# **ONSITE WASTEWATER TREATMENT SYSTEM STAKEHOLDER MEETING**

**MARCH 3, 2026**

**STANDARDS FOR APPROVAL OF PLANS  
AND CONSTRUCTION FOR  
SEWAGE DISPOSAL SYSTEMS FOR  
SINGLE-FAMILY RESIDENCES**

## 2. SEWER PIPES- BENDS

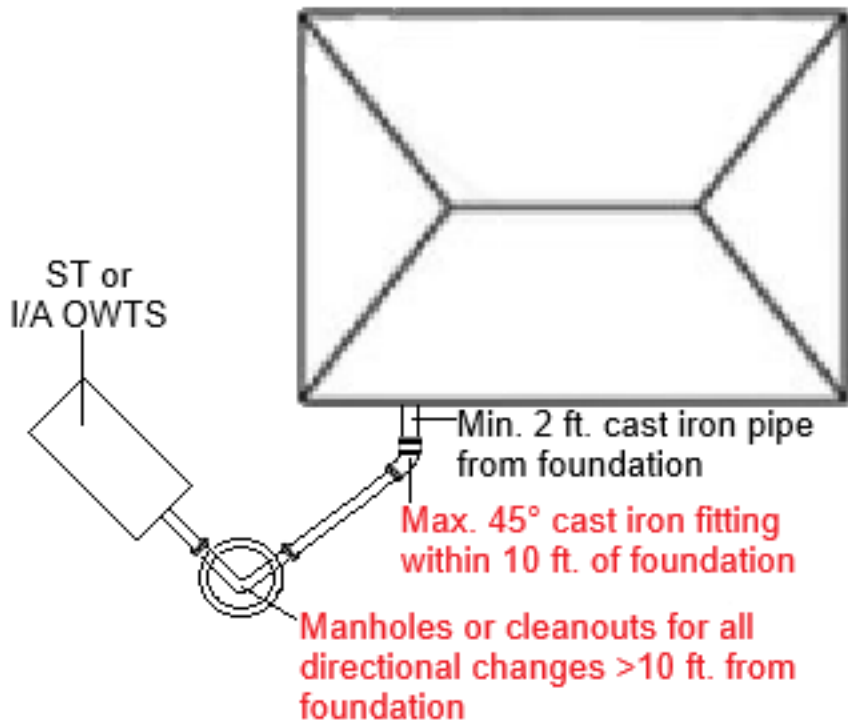
- No bends in the sewer line unless “unavoidable” or if “absolutely necessary”
  - ✓ *Some leniency given for replacement/retrofit*
  - ✓ *Very little leniency given for new construction*
- Manhole or cleanout required for directional change that is greater than 10 feet from foundation
- Bends within 10 feet of foundation must be constructed of cast-iron piping up to and including the bend

- *Recommend no bends in the sewer line*
  - ✓ *Bending of sewer pipe is at the discretion of the designer/installer*
- When a directional change is greater than 45° there must be at least 2 feet of piping between fittings
- Cleanouts must be installed prior to each total directional change of 90°

## 2. SEWER PIPES- BENDS

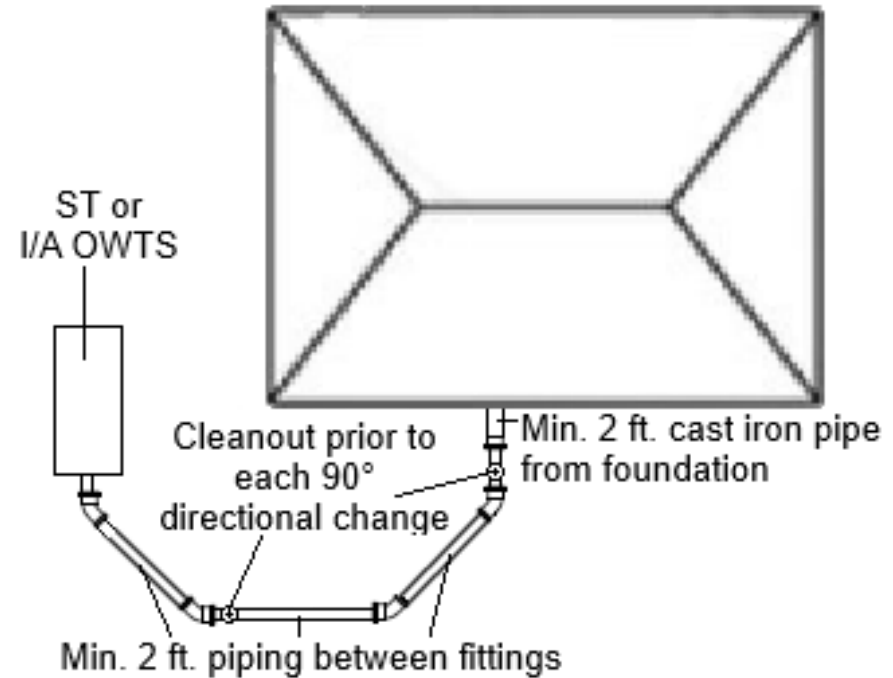
### CURRENT

(red text is proposed to be removed from standards)

\*No single fitting may exceed 45°

## 2. SEWER PIPES- JOINING

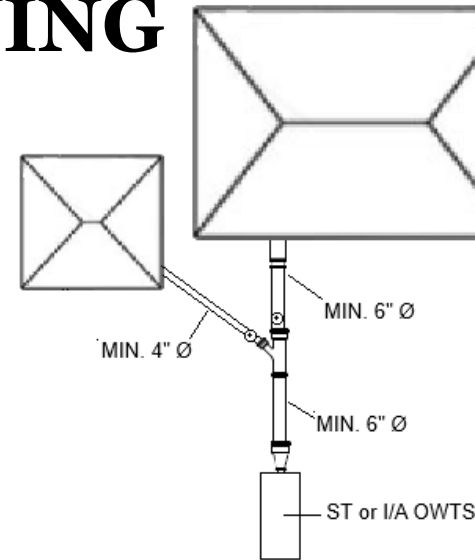
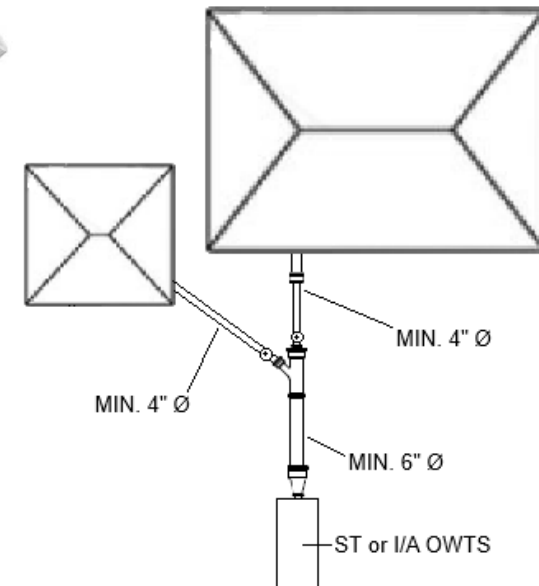
- Single or double wye fittings with maximum angle of 45° and minimum hub diameter of 6 inches
- New construction → main sewer line must be a minimum of 6 inches to utilize a wye
- Existing 4-inch sewer lines → reducer coupler must be used preceding the wye to increase the main sewer line's diameter to at least 6 inches, which must then be maintained to the septic tank or I/A OWTS
  - ✓ An eccentric reducer may be used directly preceding an I/A OWTS that requires an inlet pipe that is less than 6 inches
- Installation of a cleanout on each sewer line and within 10 feet preceding the wye fitting

# 3. SEWAGE EJECTOR SYSTEMS

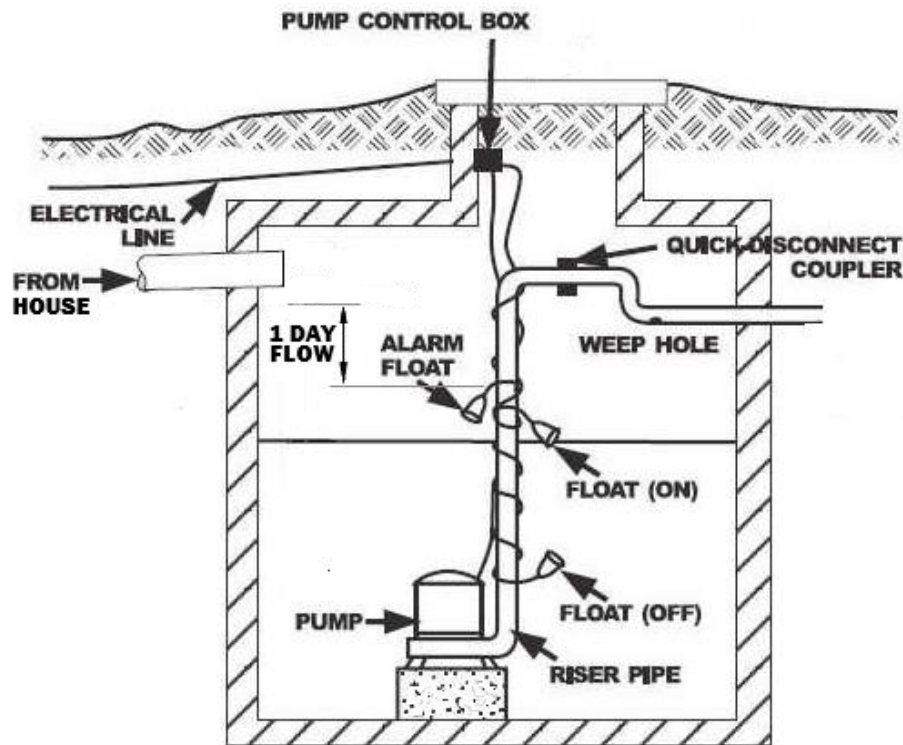
- ✓ Pumps must be rated for sewage and capable of handling at least 2-inch spherical solids.
- ✓ No grinder pumps prior to an I/A OWTS.
- ✓ When grinder pumps are used they must have a minimum discharge opening of at least 1 1/4 inch.

- ✓ Dual pumps are required
- ✓ If the sewage ejector system tank is sized to provide a minimum of one day's design flow storage between the high-water alarm level and 3 inches below tank inlet invert a single pump may be used

# 3. SEWAGE EJECTOR SYSTEMS

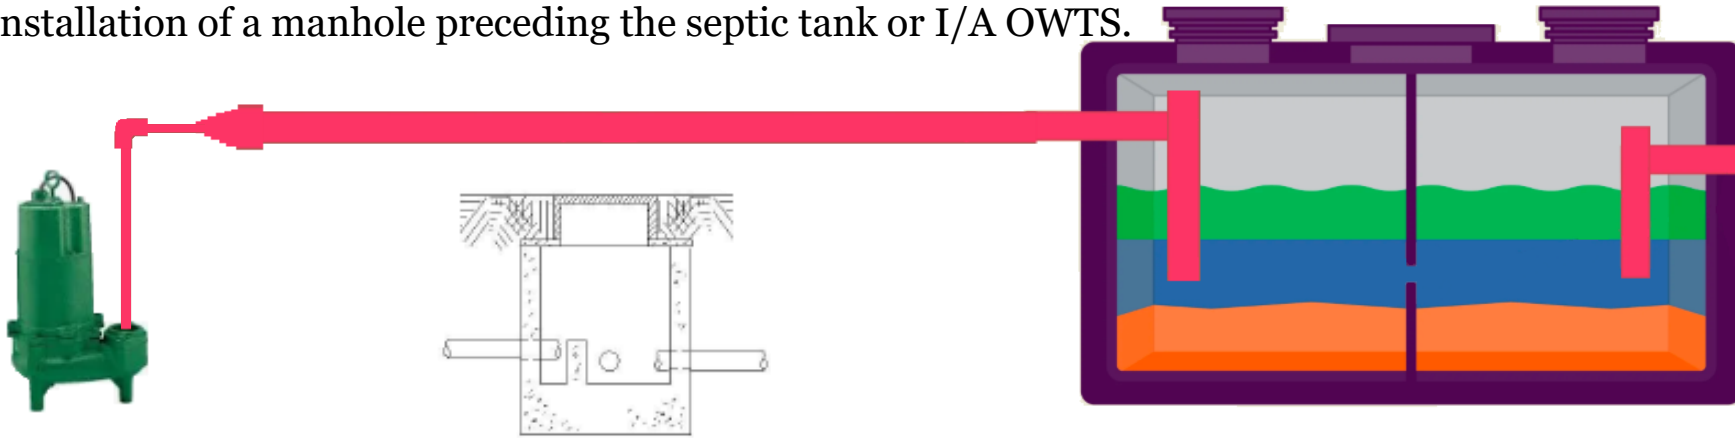
- Pressure and settling disturbance in the septic tank or I/A OWTS must be reduced to the greatest extent possible by:
  - transitioning to a larger-diameter, gravity pipe at a point as far from the septic tank or I/A OWTS inlet as possible; OR
  - installation of a manhole preceding the septic tank or I/A OWTS.

# 4. PRESSURIZED SHALLOW DRAINFIELDS (PSD)

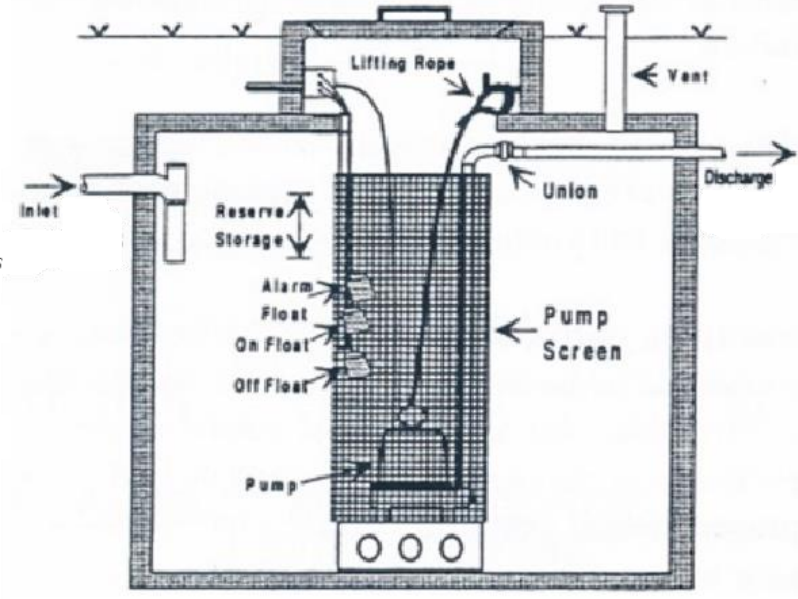
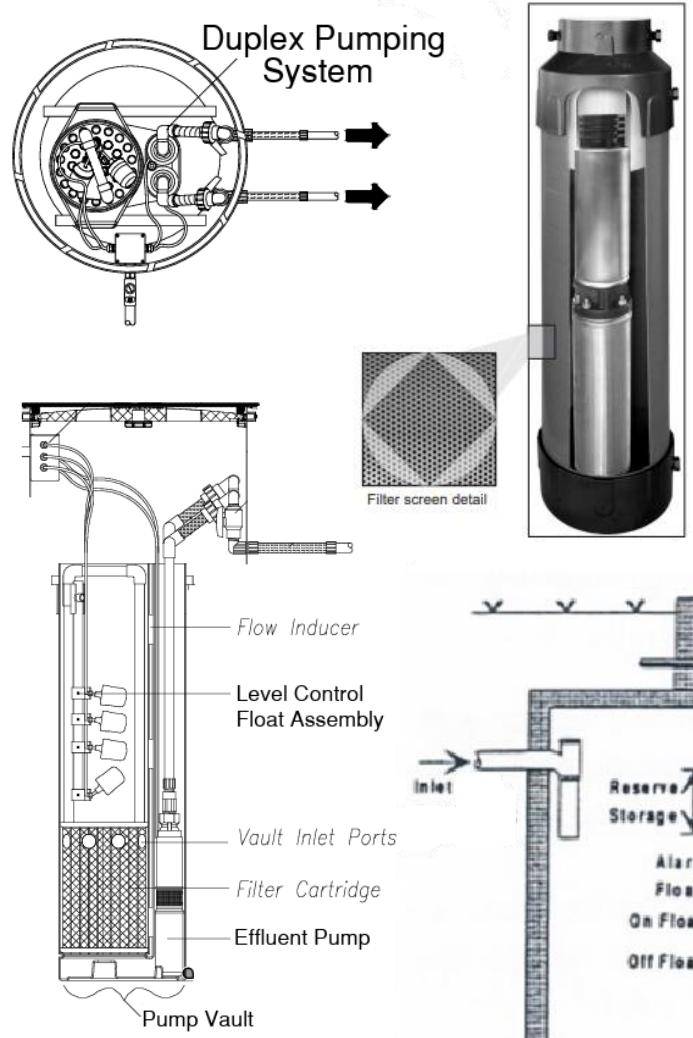
- New minimum design requirements:
  - A dosing tank and pump that is fully independent of the treatment process of the preceding I/A OWTS.
  - Dual pumps, unless the dosing tank is sized to provide a minimum of one day's design flow storage between the high-water alarm level and the 3 inches below the inlet invert of the tank.
  - Screened pump vault/basket or inline effluent filter at pump tank.

## 4. PRESSURIZED SHALLOW DRAINFIELDS (PSD)

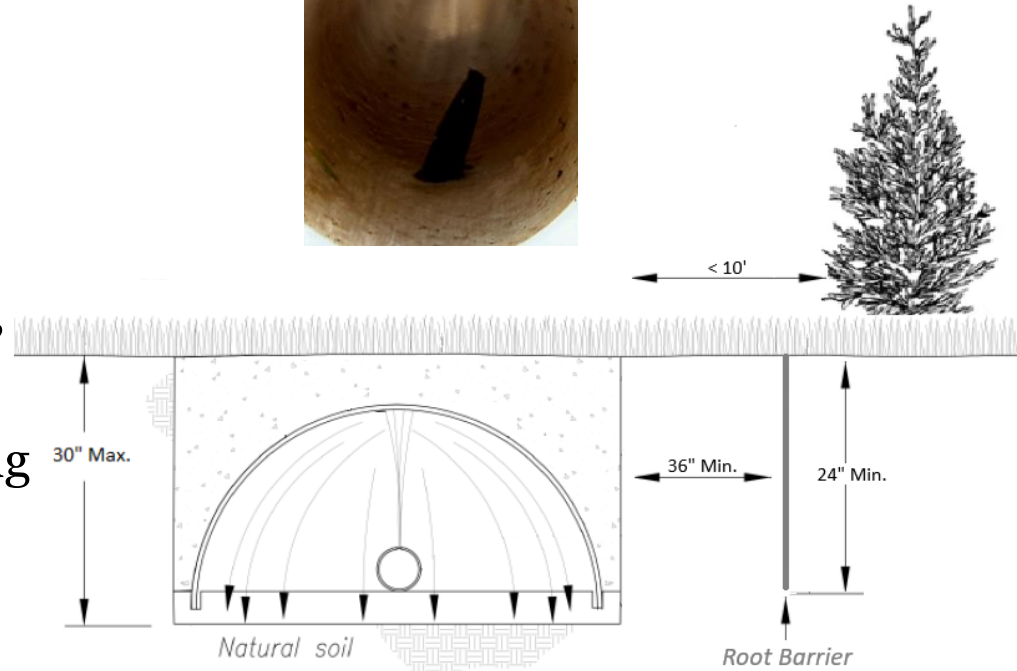
➤ Allow the use of root barrier when unable to meet minimum separation distance of 10 feet between PSD and widest point of trees/shrubs

- Minimum 2 feet vertically from grade
- Minimum 3 feet horizontally from trench edge

# 6. ABSORPTION TRENCH SYSTEMS

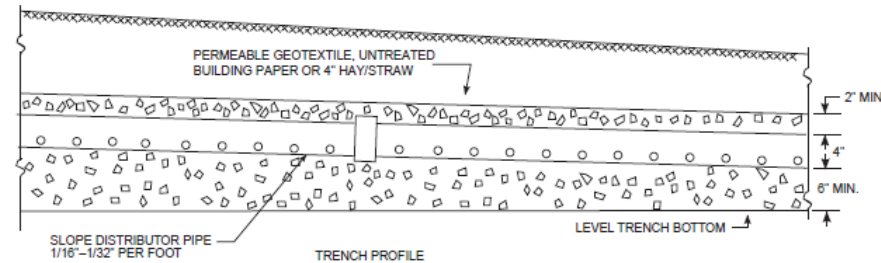
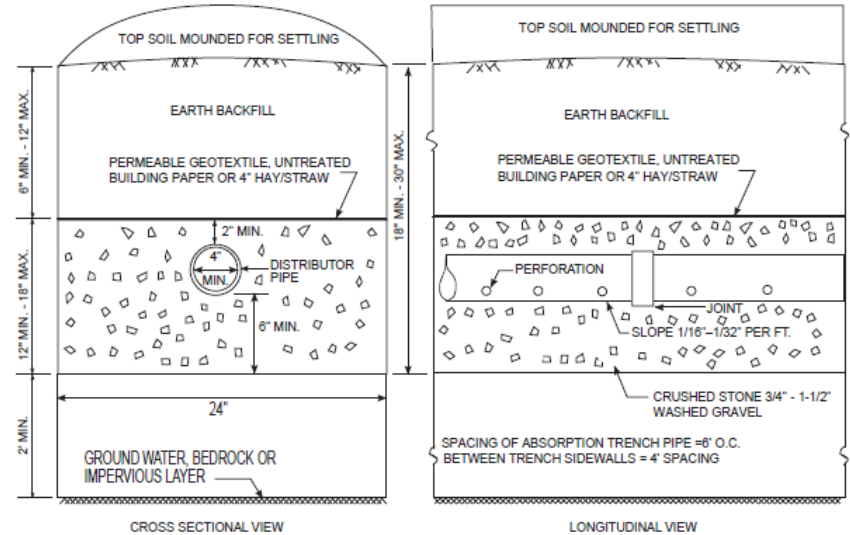
- Not in **CURRENT** standards
- **PROPOSED:** Add absorption trench system (a.k.a. “Pipe & Stone”)
  - 110 gallons per bedroom per day
  - 2 ft. wide trenches
  - 4 ft. between trenches
  - Table 7 application rates
- Must be designed in accordance with NYSDOH Appendix 75-A
  - Commonly used system in other parts of New York
- Not recommended to be installed under paved/compacted surfaces
  - If required, then use of a preceding I/A OWTS is recommended
- Requires preceding effluent filter and/or I/A OWTS

# 7. LEACHING GALLEYS

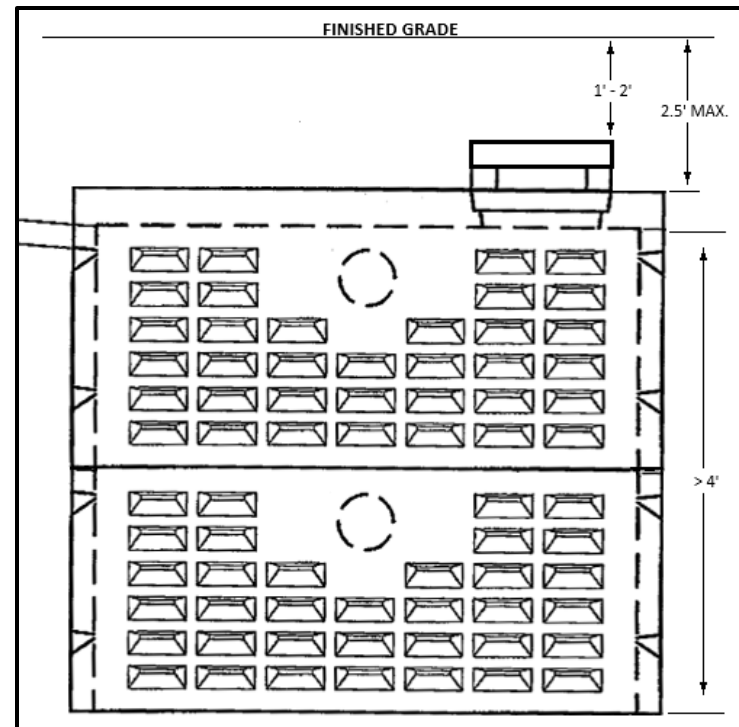
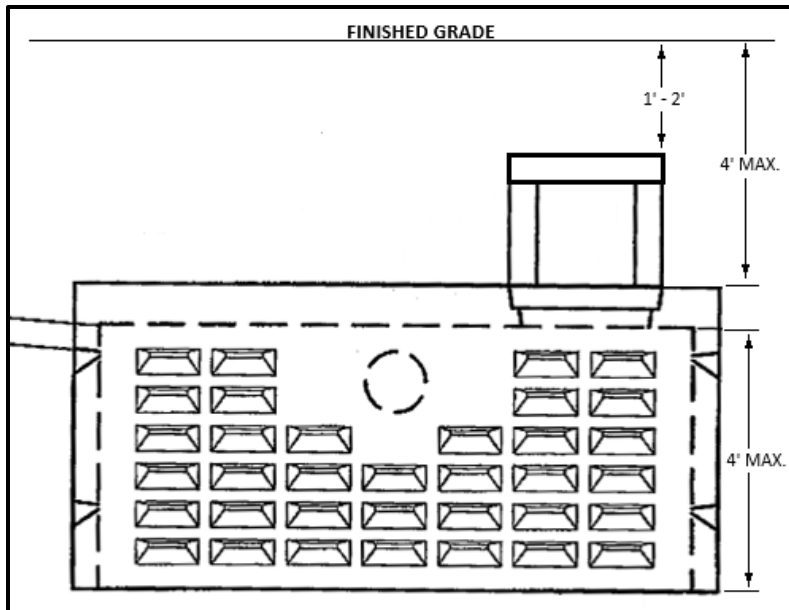
- LG with effective depths of 4 feet or less
  - Maximum burial depth to top of galley = 4 feet
- LG with effective depths greater than 4 feet or stacked LG
  - Maximum burial depth to top of galley = 2.5 feet
- Clarify that the interior shall be open and not filled with any material (i.e., stone, wood chips, etc.)
